**REGULAR MEETING OF THE UNITED LAGUNA HILLS MUTUAL
ARCHITECTURAL CONTROL AND STANDARDS COMMITTEE**

**Wednesday, January 17, 2018 – 9:30 a.m.
Laguna Woods Village Community Center Sycamore Room
24351 El Toro Road**

DATE: January 17, 2018
FOR: Architectural Controls and Standards Committee
SUBJECT: Conversion of Architectural File Drawings to CAD

DATE: January 17, 2018
FOR: Architectural Control and Standards Committee
SUBJECT: Variance Request: Mr. Ohsoon Chun of 105-C (San Sebastian, 7)
Extend Living Room onto Existing Patio

CHUN RESIDENCE
105-C VIA ESTRADA
LAGUNA WOODS, CA

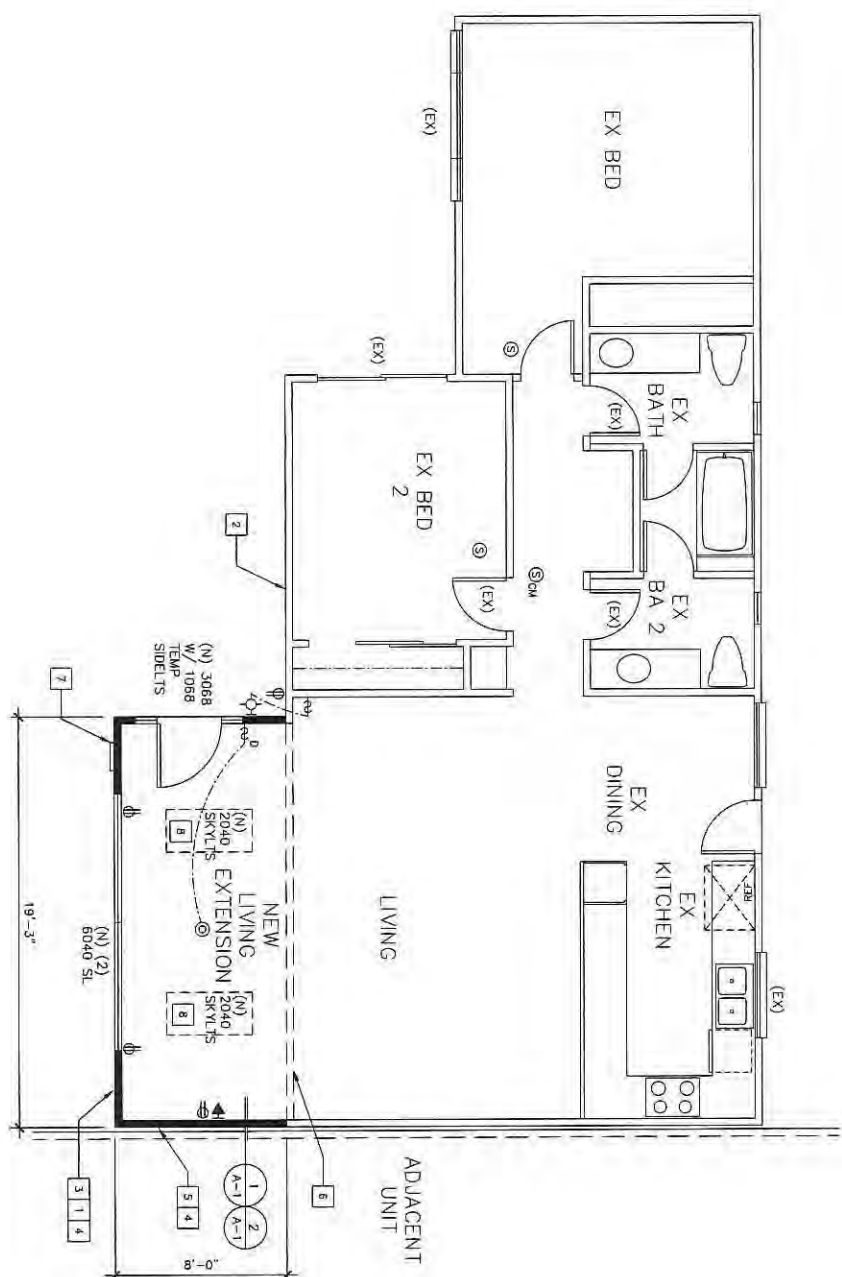
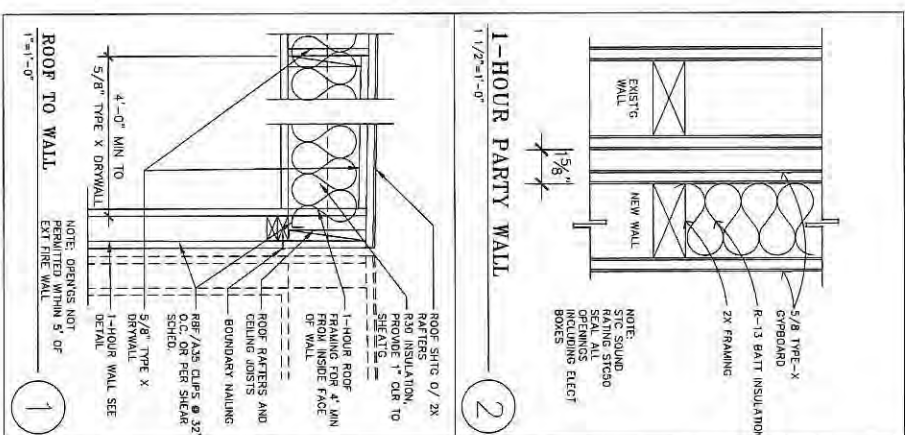
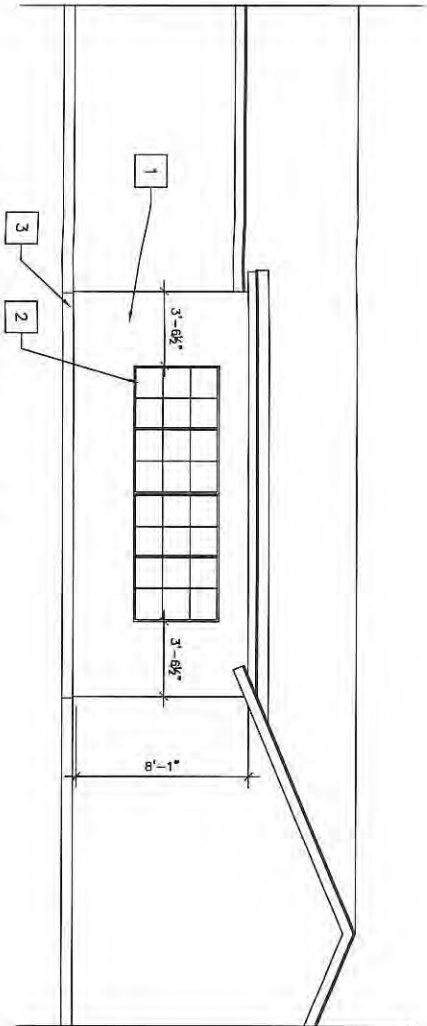
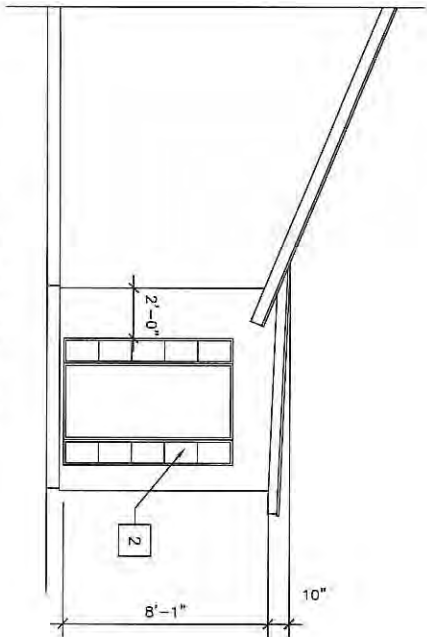
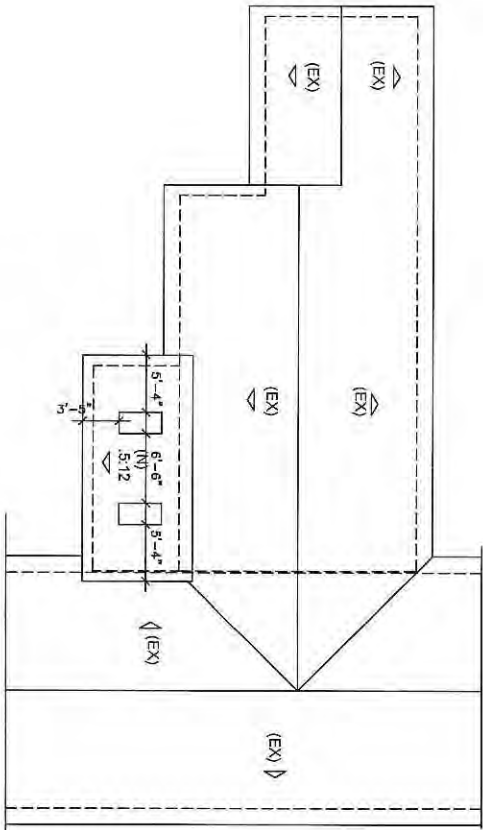
The proposed living room extension involves removing the existing patio block wall which is four feet, eight inches tall and existing concrete slab which is fifteen feet, four inches wide by seven feet, seven inches deep. The proposal calls for a new concrete foundation and slab that encompasses the entire front patio area including the existing four foot by eight foot landscape area.

The living room extension will add approximately one hundred fifty four square feet of living space. This will be accomplished by removing the existing exterior wall and constructing a new wood frame structure with a stucco finish. The roof will be a Built-Up-Roof (BUR) system with a four percent slope and materials used to match the existing roof.

As part of the extension, the entry door will be relocated to the south wall and will open onto the existing walkway. One large, six foot wide by four foot tall sliding window will be installed on the new east wall.

Staff recommends the Board approve the request to extend living room onto existing patio with the conditions as stated in Appendix A.

Existing Plan

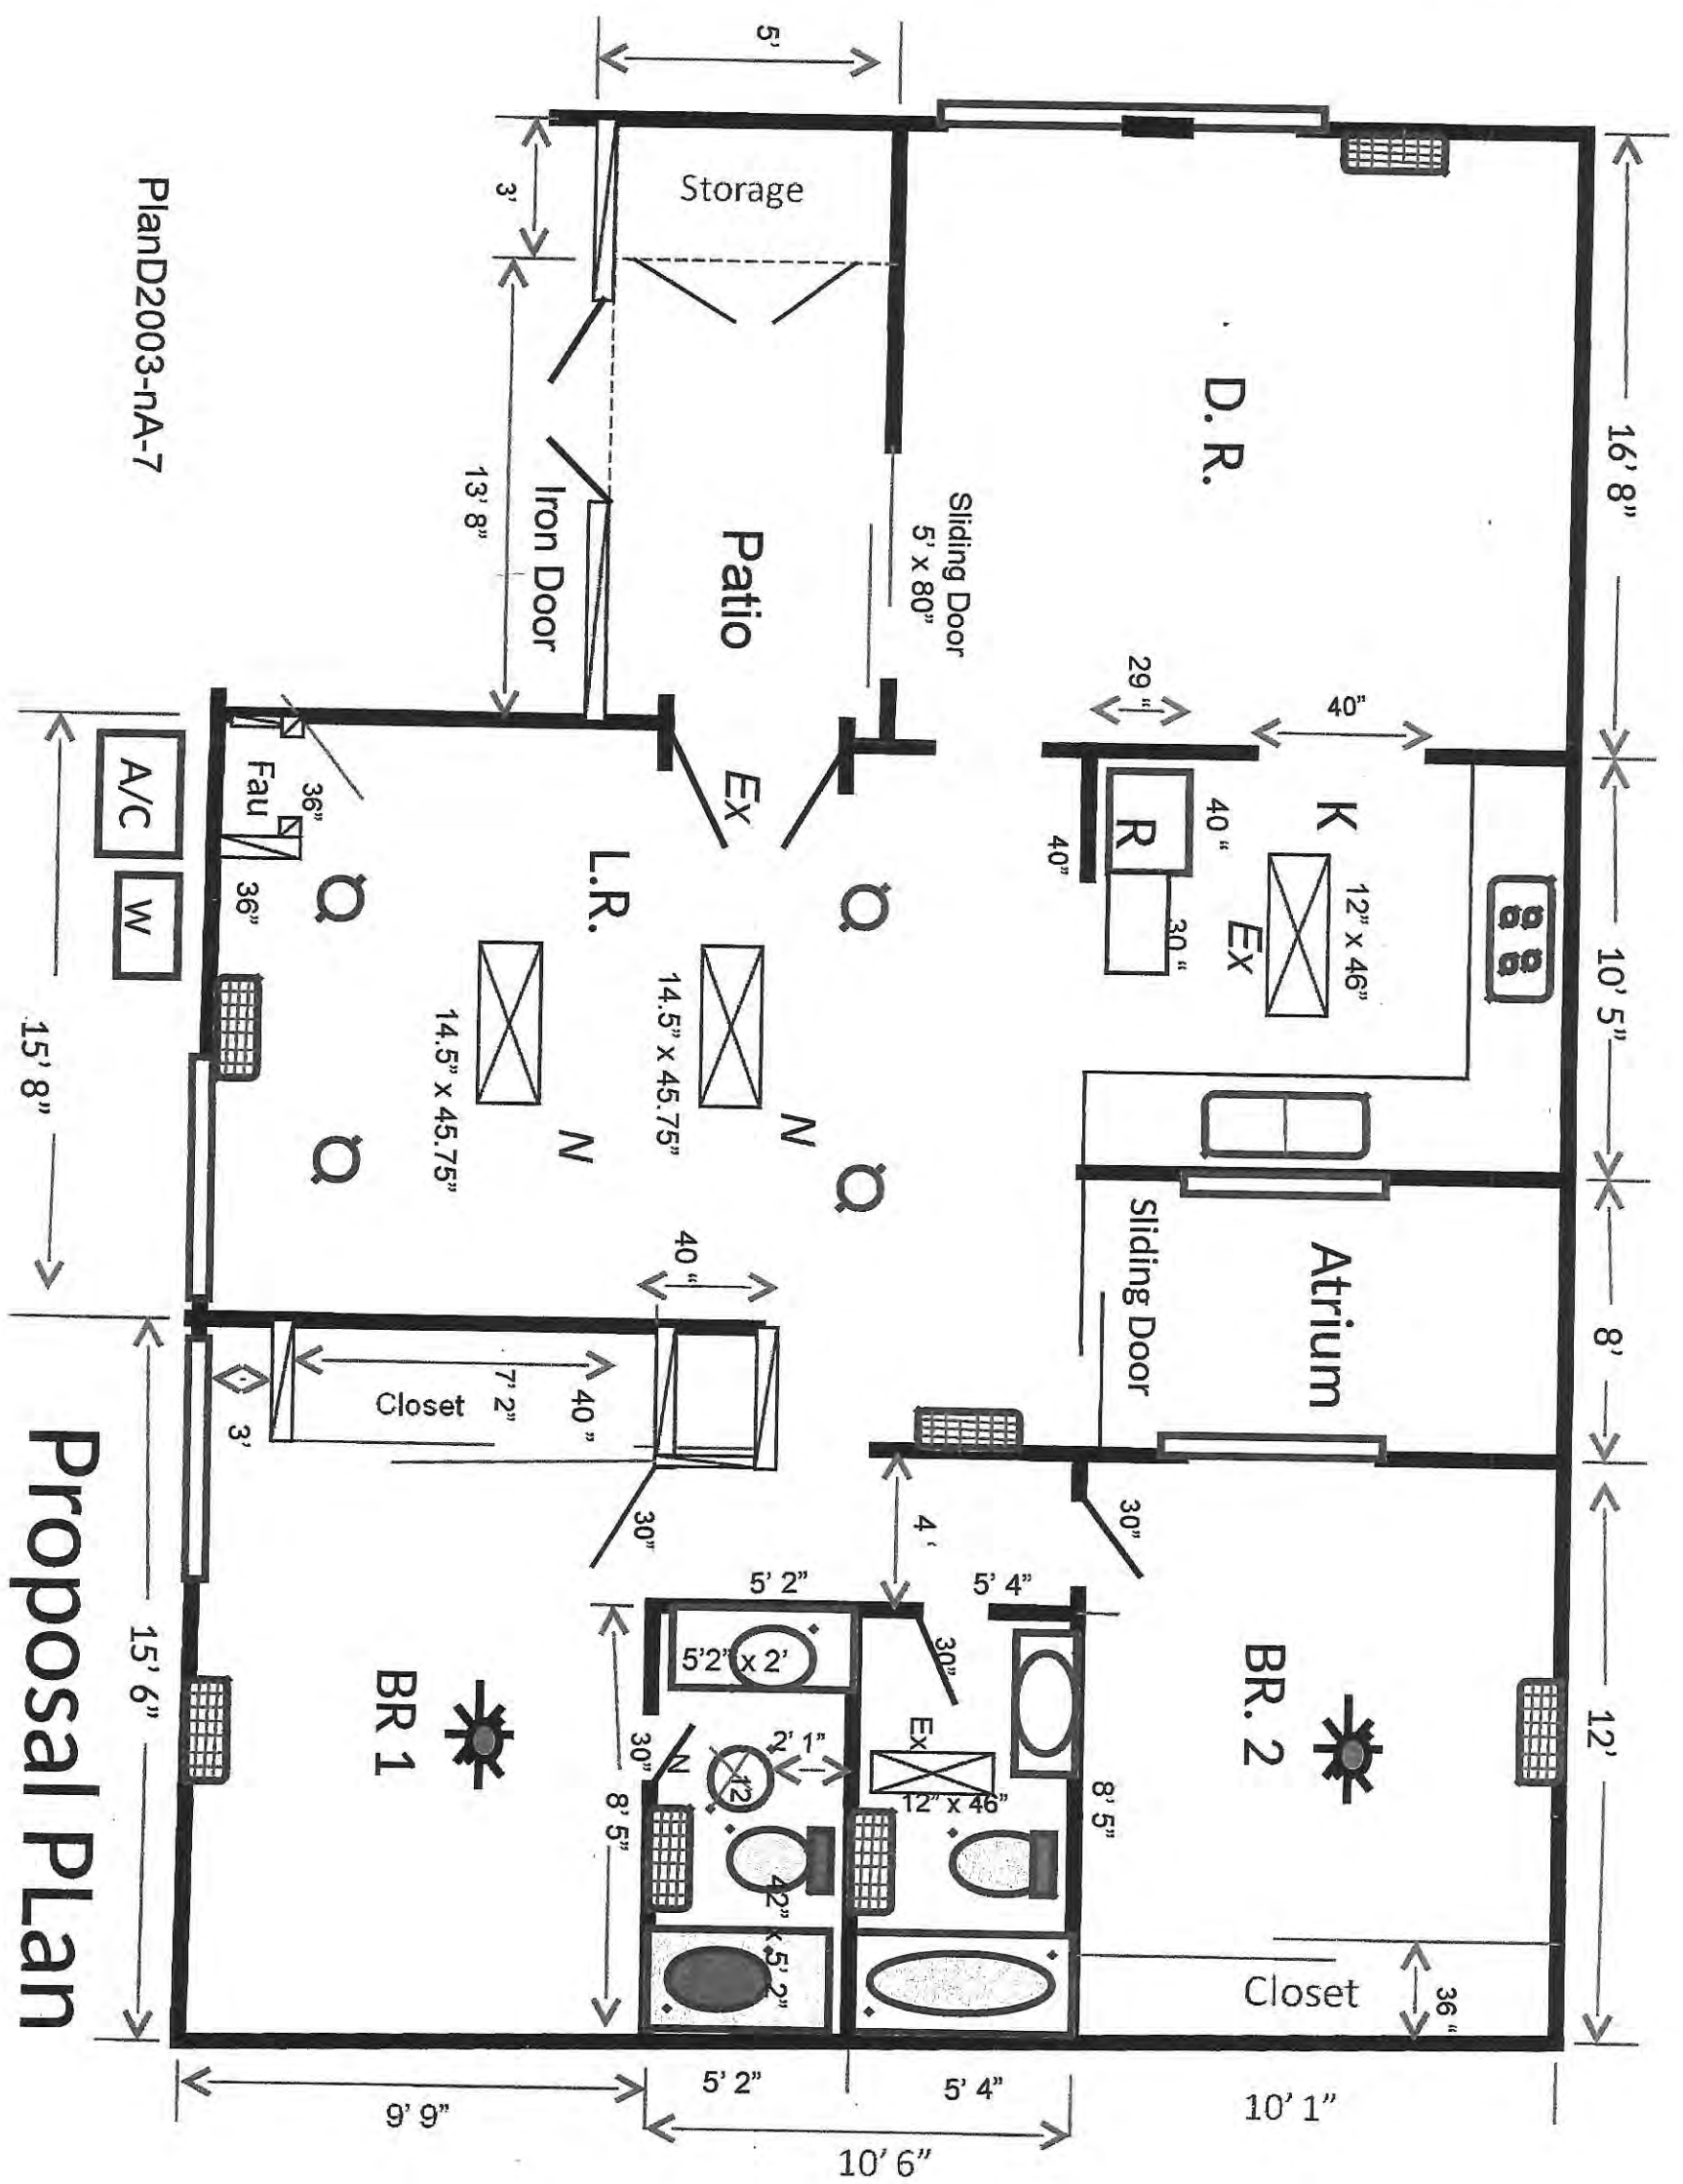
A closet relocation was approved for 449-H December 2017. Due to Madrid floor plans allowing for kitchen window to door conversions as a Standard, there are no previous variance requests on file for installing an opening.
